PLANNING AND DEVELOPMENT SERVICES STAFF REPORT

**SUBJECT: Staybridge Suites & Retail Rezoning and Planned Project Site Plan
File Nos. SP14-057 & Z14-028**

PLANNING AND DEVELOPMENT SERVICES STAFF REPORT

**SUBJECT: Staybridge Suites & Retail Rezoning and Planned Project Site Plan
File Nos. SP14-057 & Z14-028**

SHEET TITLE:
SITE LAYOUT AND PAVING PLAN

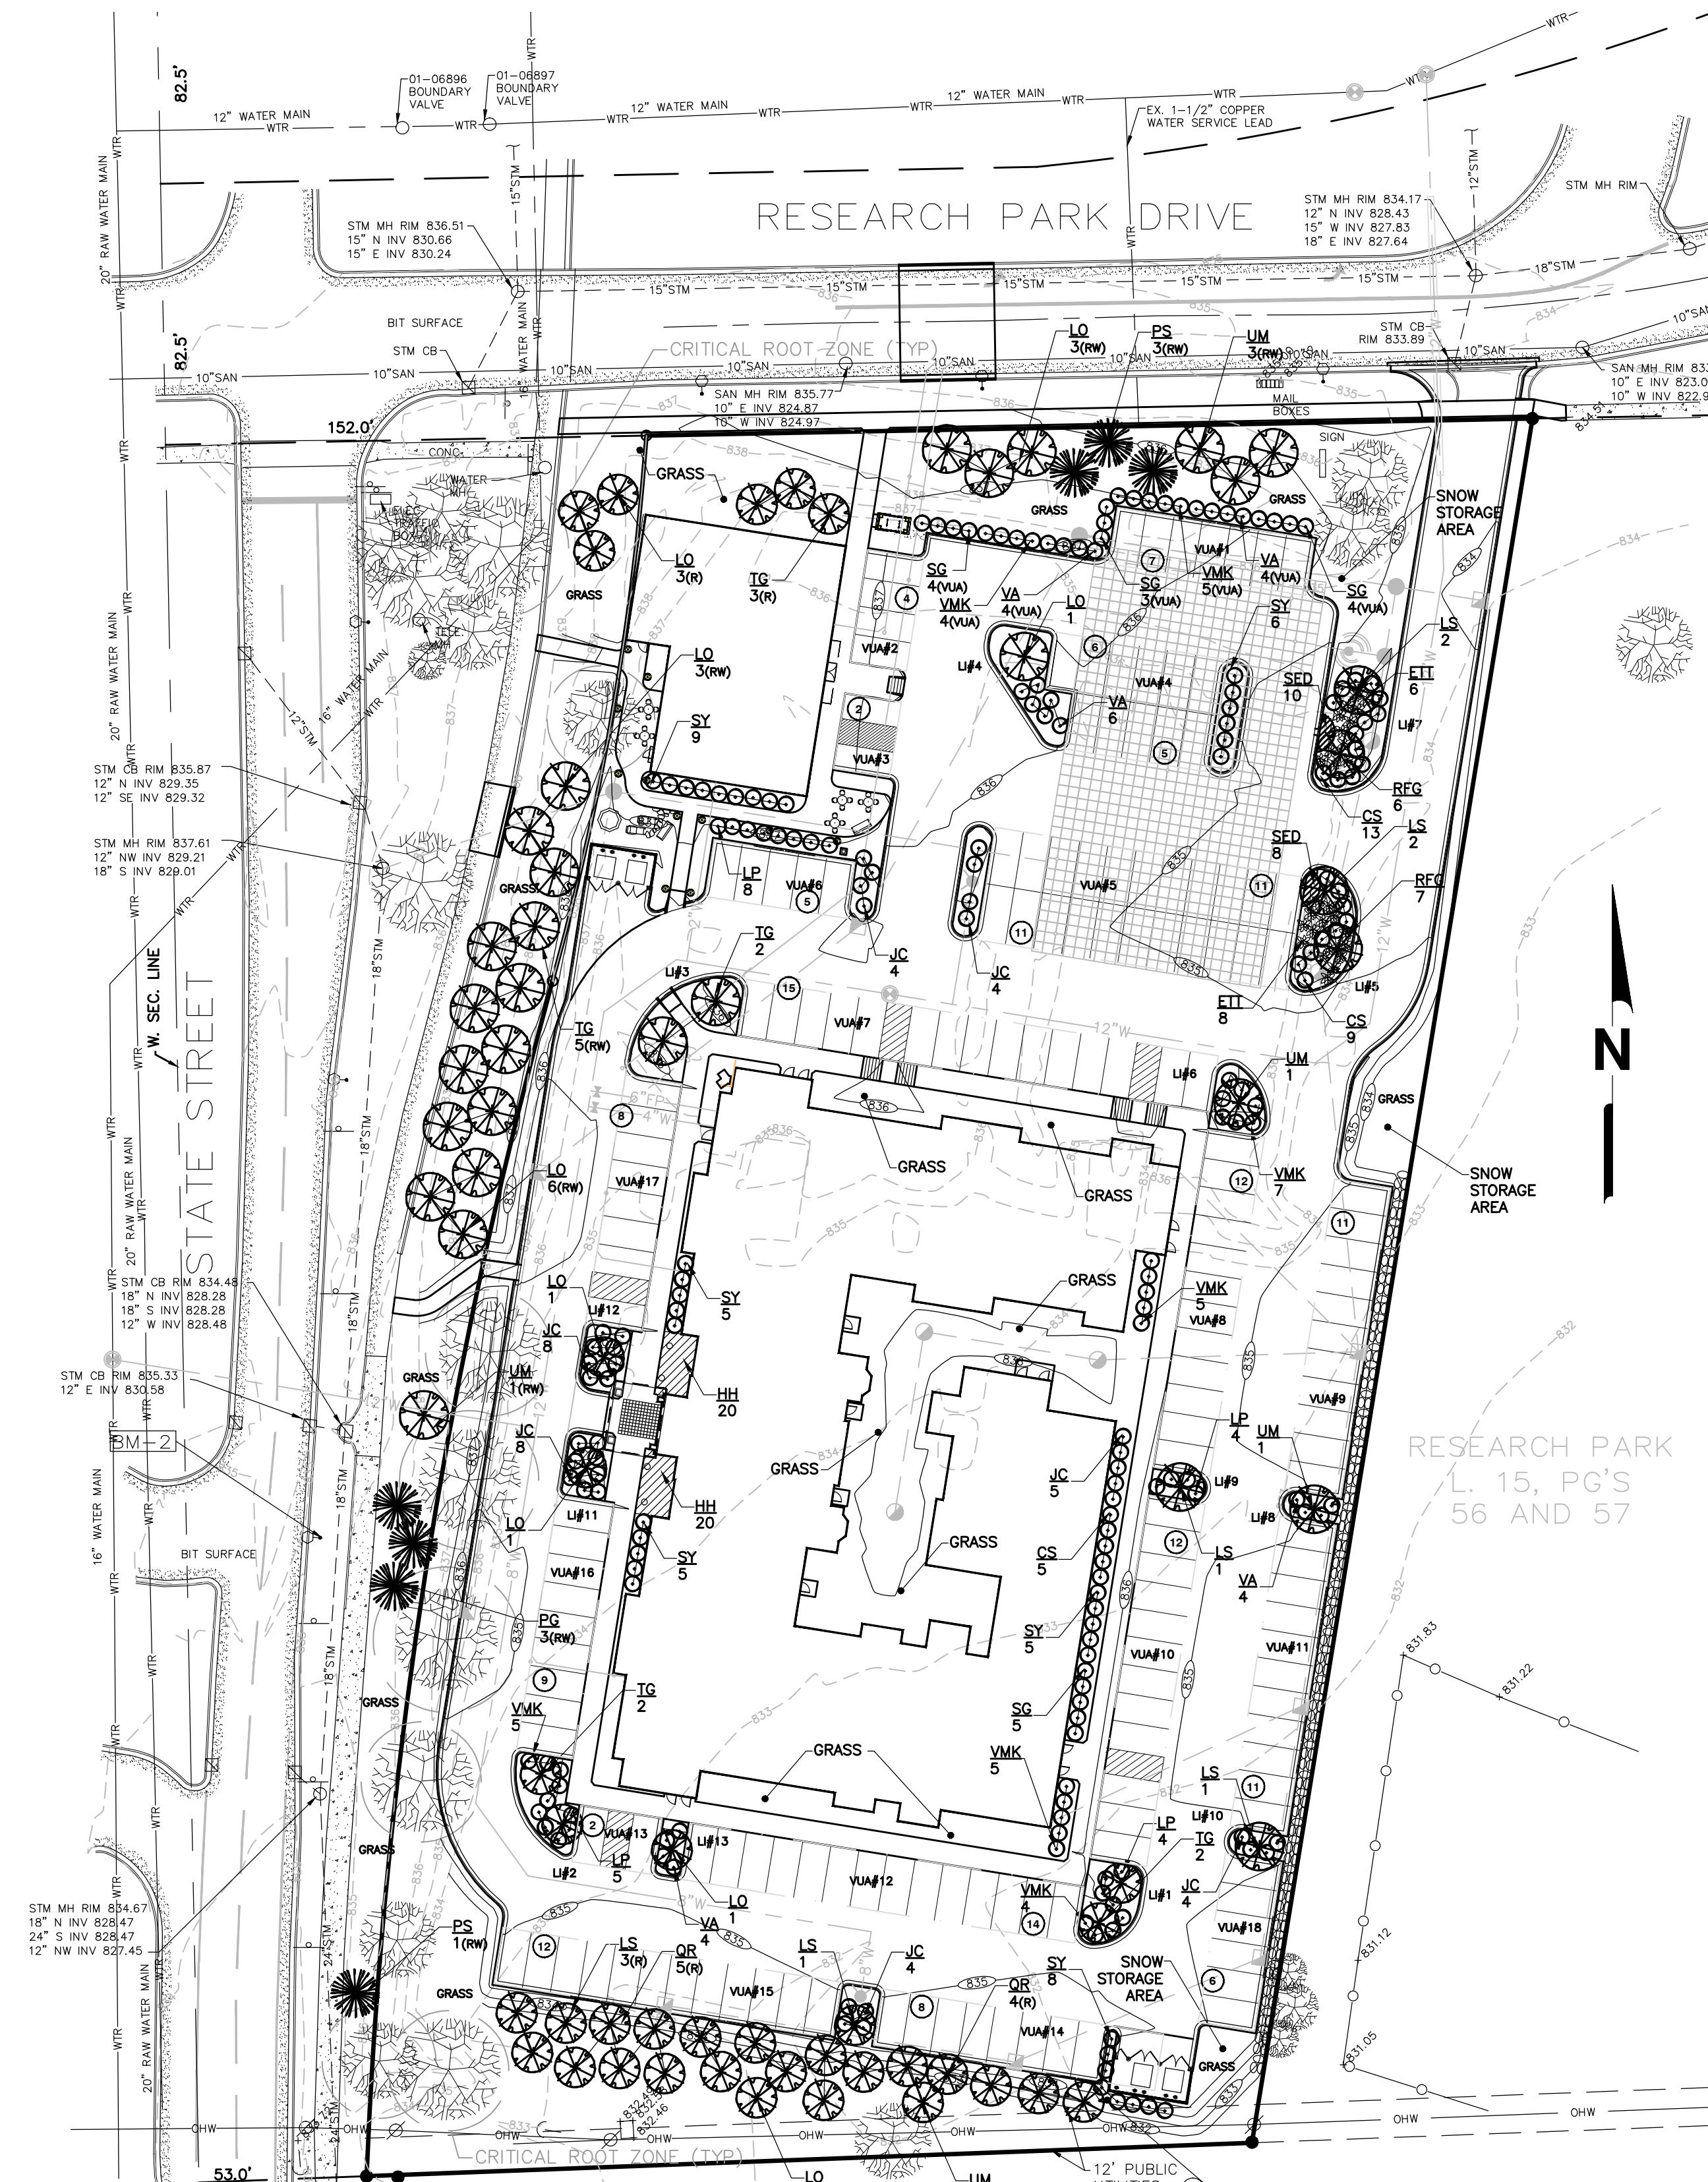
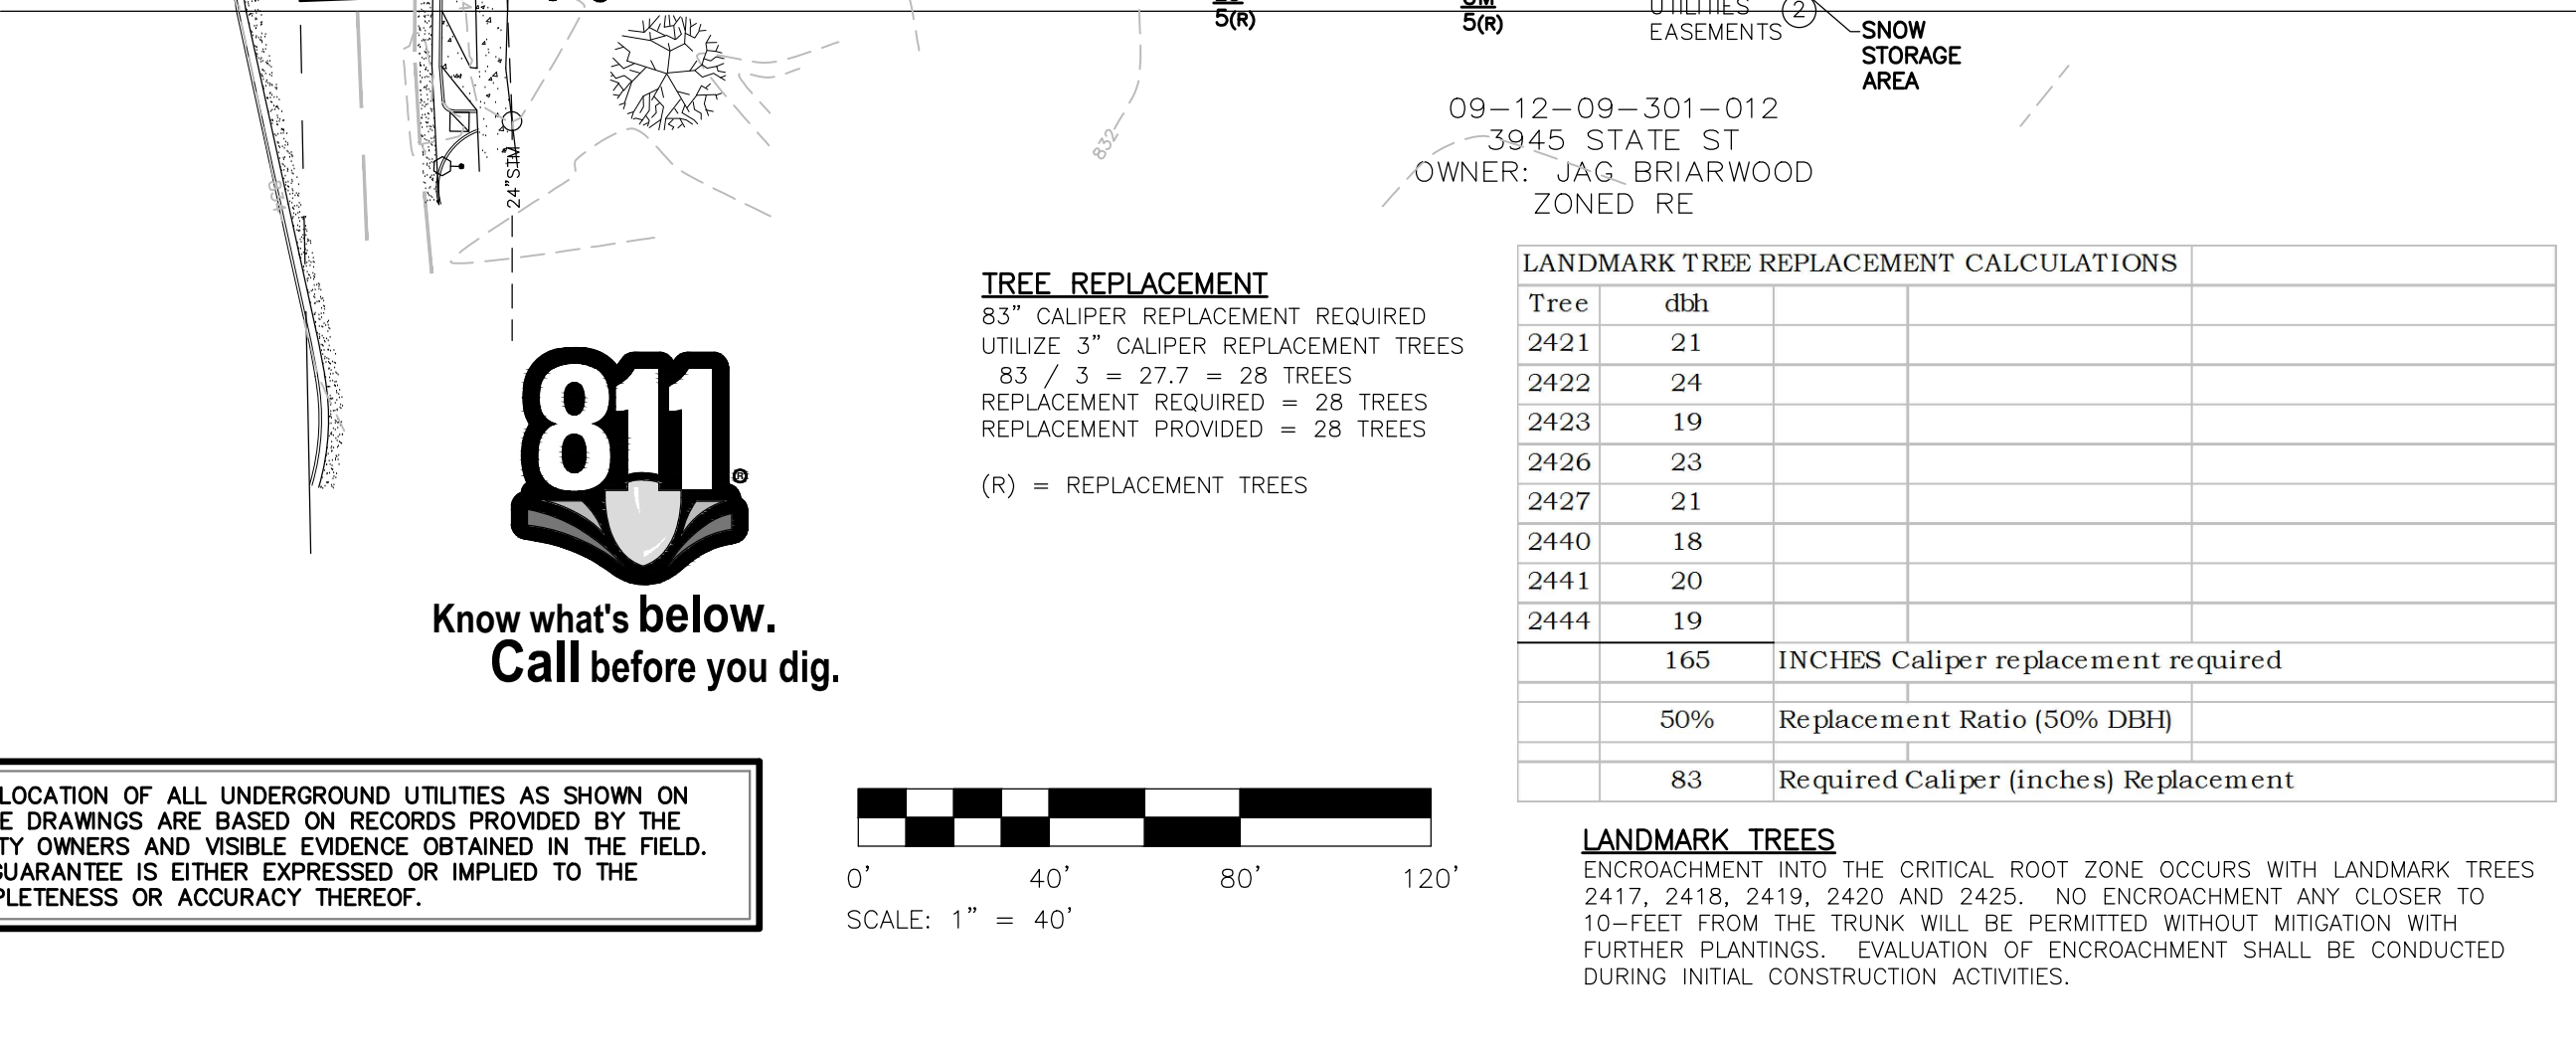
The previously submitted site plan layout showed encroachment of a parking aisle into the critical root zone of five landmark trees along the west side of this site.

Urban Forestry – The site layout shows encroachment into the critical root zone of the landmark trees (#2417, 2418, 2419, 2420 and 2425). Encroachment into the critical root zone of the landmark trees is not permitted without City approval at the time of site plan approval. Staff does not support encroachment into the critical root zone of these trees. The current encroachment shown is less than 5 feet, which does not take into consideration the encroachment that will occur for the construction of the curb which will move the encroachment to less than 2 feet from the trunk. Please revise drawings to remove encroachment from the critical root zone of these trees.

To reduce impacts on the critical root zones of the landmark trees, the revised site layout reduced the drives on both the east and west side of the hotel from 24-feet to 22-feet and shifted the building and parking areas to the east. These changes shifted the western line of the proposed curb by approximately 4.25 feet east to be in the approximate location of the existing pavement. This shift does not require mitigation for the landmark trees.

DATE: _____
 DRAWN: ACA
 CHECKED: FTG
 SCALE: 1"=40'
 JOB NO.: BD-14-322
 SHEET TITLE: LANDSCAPE PLAN AND DETAILS
 SHEET
L1.0

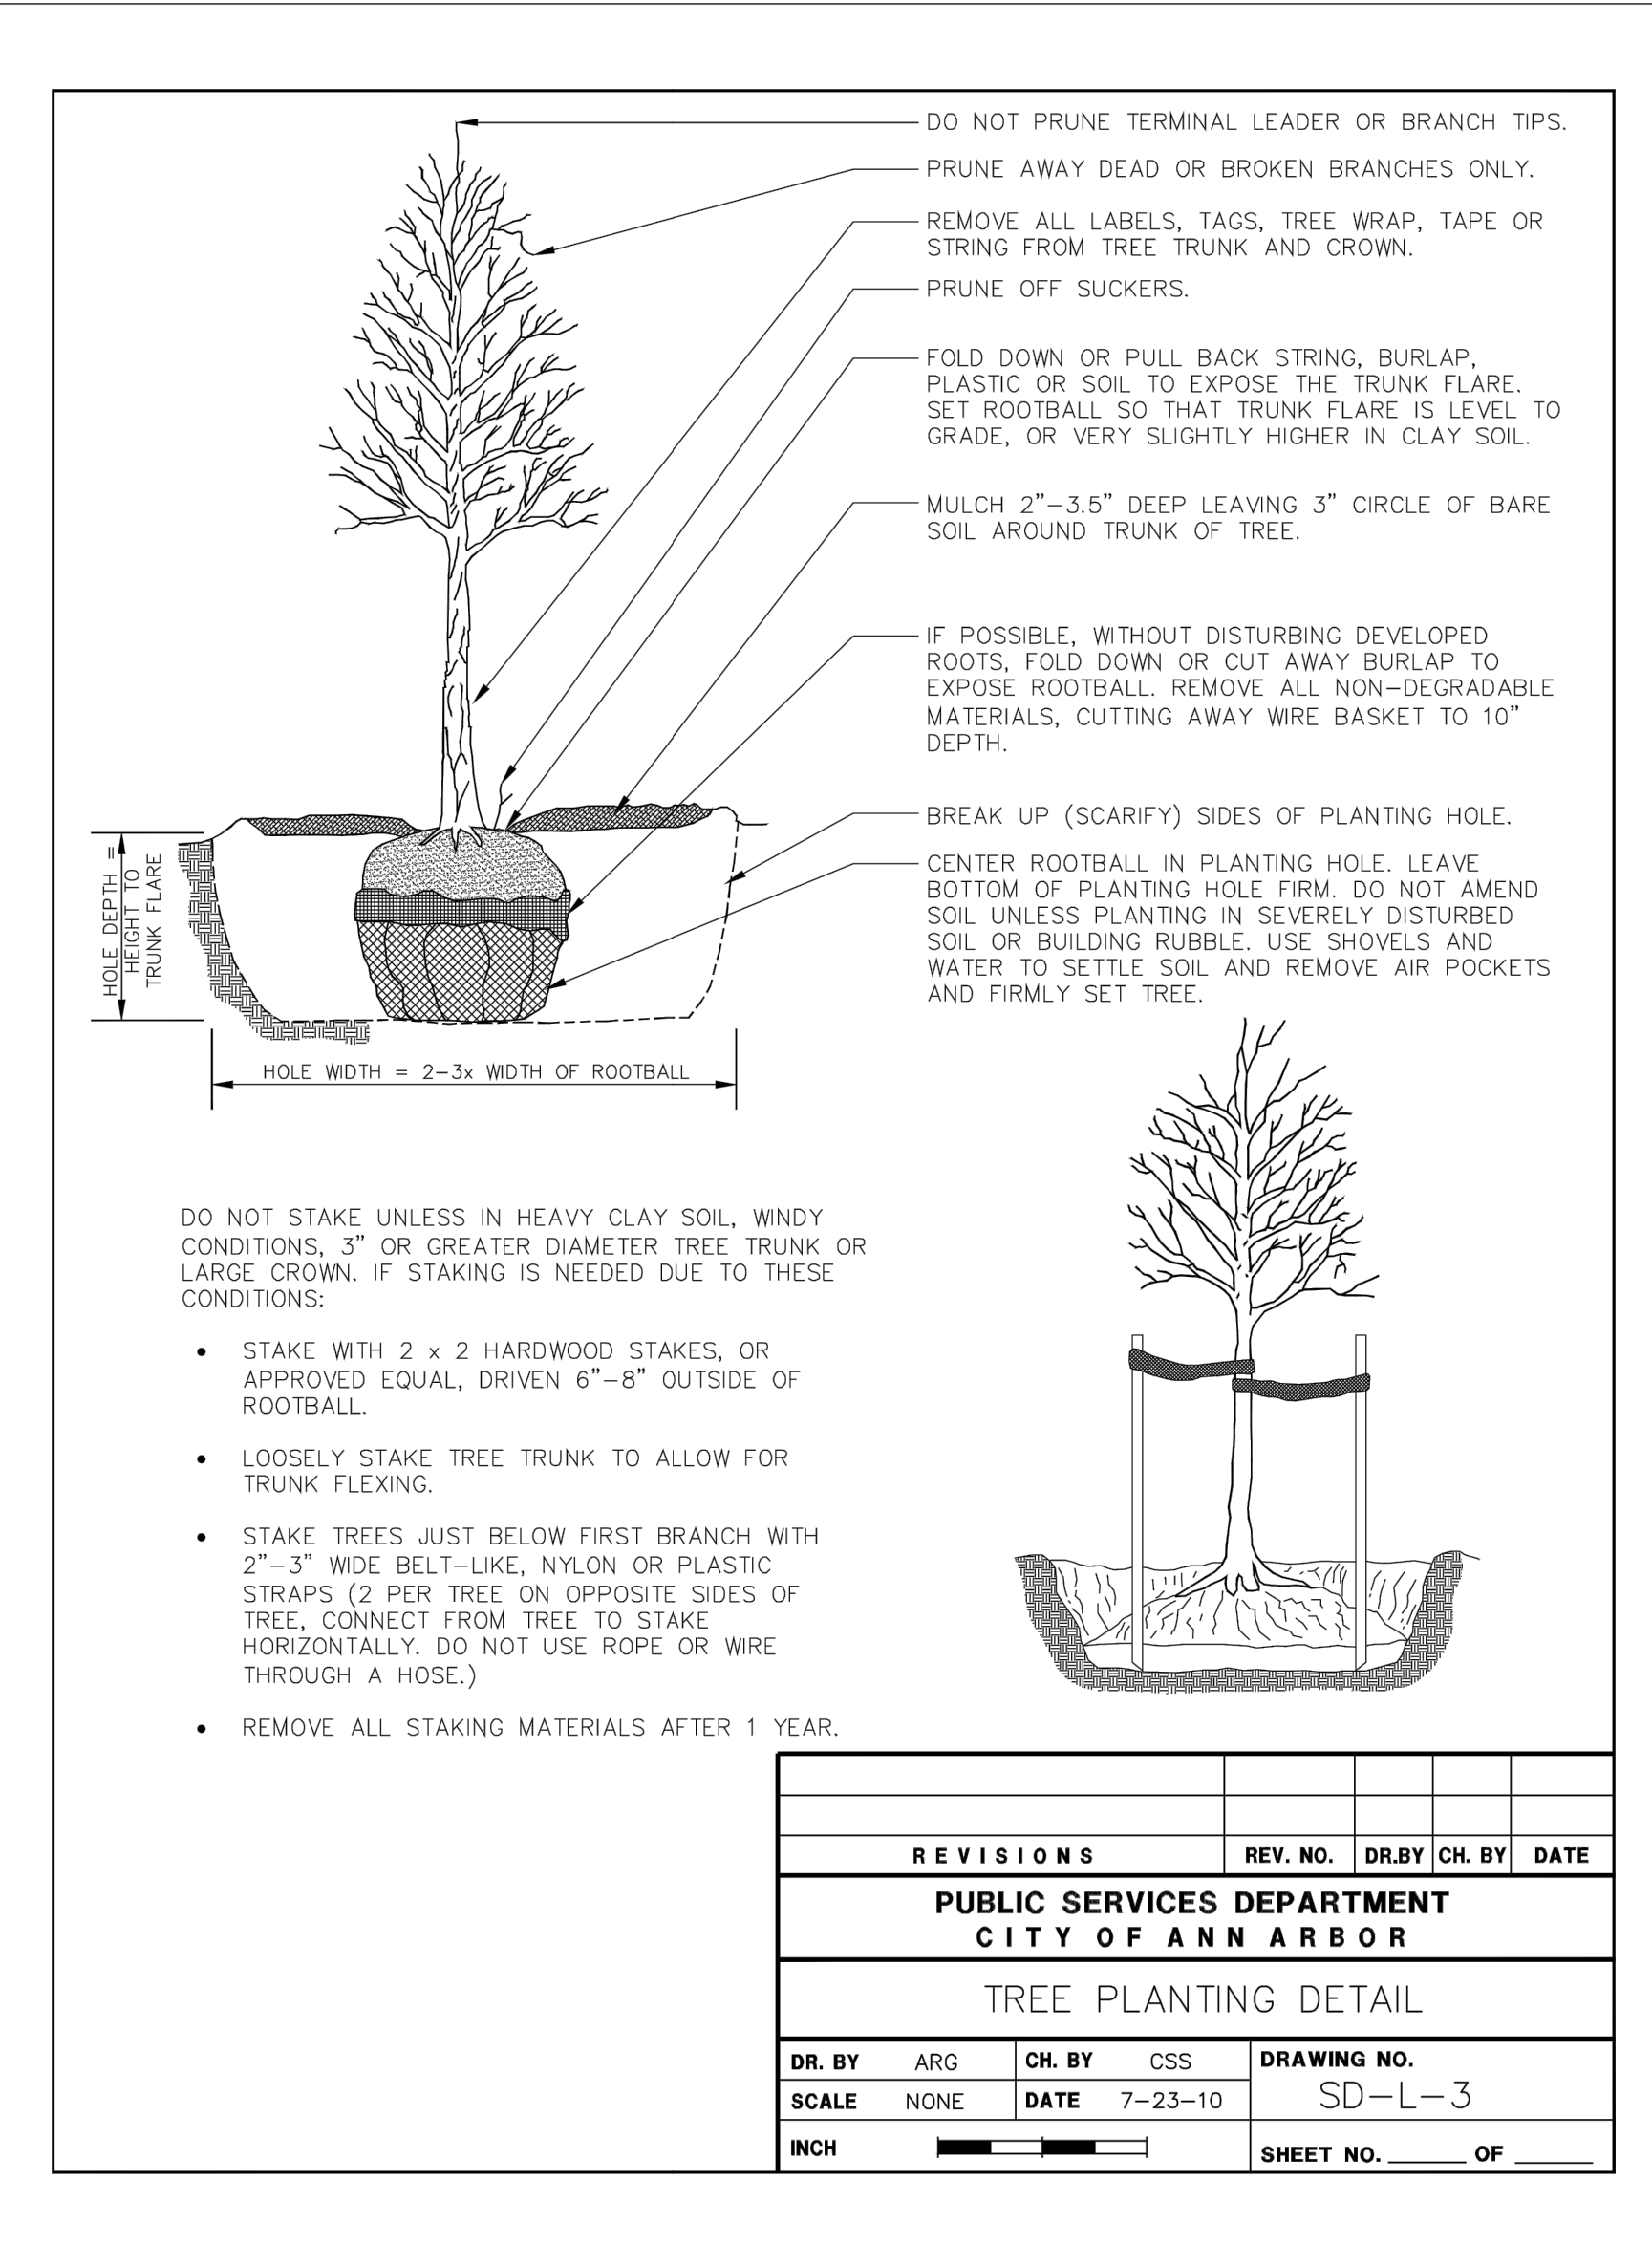
A hedge, dense shrub planting, landform berm, wall or combination is required for right-of-way screening of the vehicular use area. This screening is required along S. State Street and was shown on the last submittal only in the areas outside of the critical root zone of the landmark trees. A Landscape Modification has been requested to allow reduction of the continuous hedge, berm or wall requirement along S. State Street because placement of plantings in the critical root zones would cause damage to the existing landmark trees. The petitioner has proposed plantings along S. State Street outside of the critical root zones of the landmark trees (Landscape Modification Application attached).

A hedge, dense shrub planting, landform berm, wall or combination is required in the right-of-way screening of the vehicular use area. This screening is required along S. State Street and has not been shown on the landscape plan. If adherence to this standard will damage the landmark trees in this area, a Landscape Modification may be submitted.

Staff recommends that the landscape modification request for Staybridge Suites & Retail be **approved** because the modifications are consistent with the intent of the ordinance by waiving the required right-of-way screening located in the critical root zones of landmark trees.

5:608(2)(c)(iv)-Existing vegetation and landscaping are located or spaced in such a manner that the addition of required landscaping would be detrimental to the plan materials.
There are eight (8) existing trees, four (4) of which are Landmark Trees, along the roadway frontage of S. State Street. The installation of any form of right-of-way screening (hedge/berm/wall) would cause damage to the existing trees.
